Access Compliance Report Public Rights-of-Way (Curb Ramps)

Main Street: HOPI_RD Cross Street: DALE_ST Location: S

ADA ID: RPAT211129132401 Ramp Type: Type 7 - Directional 2 Initial Pass/Fail: Fail Overall Compliance: No Severity Score: 2

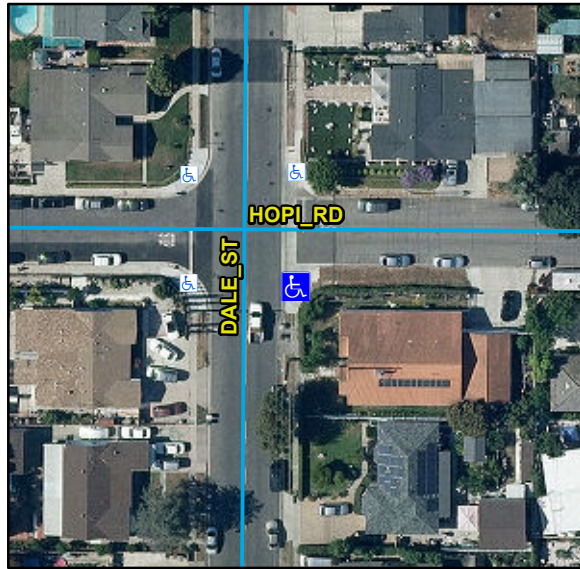
Compliance	Description	Data	Compliance	Description	Data
N/A	Ramp Length (in)	137	N/A	Flare Type LT	
Yes	Ramp Width (in)	48			N/A
Yes	Ramp Run Slope (%)	4.4	N/A	Flare Slope LT (%)	N/A
No	Ramp Cross Slope (%)	2.6	N/A	Flare Traversable LT	N/A
N/A	Grade Break	N/A	N/A	Flare Type RT	
N/A	Grade Break Slope (%)	N/A			N/A
N/A	Grade Break Cross Slope (%)	N/A	N/A	Flare Slope RT (%)	N/A
	Addl Para Ramp Left?	N/A	N/A	Flare Traversable RT	N/A
	Addl Para Ramp Right?	N/A	N/A	DWS Provided	N/A
N/A	Landing Present	N/A	N/A	DWS Contrast	N/A
N/A	Landing Length (in)	N/A	N/A	DWS Length (in)	N/A
N/A	Landing Width (in)	N/A	N/A	DWS Full Width	N/A
N/A	Landing Run Slope (%)	N/A		DWS Offset Type	N/A
N/A	Landing Cross Slope (%)	N/A	N/A	DWS Left Offset (in)	N/A
N/A	Landing Movement Obstructed?	N/A	N/A	DWS Right Offset (in)	N/A
	Landing Movement Type	N/A			
N/A	Landing Shared	N/A			
N/A	Marked Crosswalk 1	No	N/A	Clear Space	N/A
	Crossing 1 Direction	N	N/A	Clear Space To Crosswalk (in)	N/A

Remove & Replace Entire Ramp.

R304.5.3, STD 1115
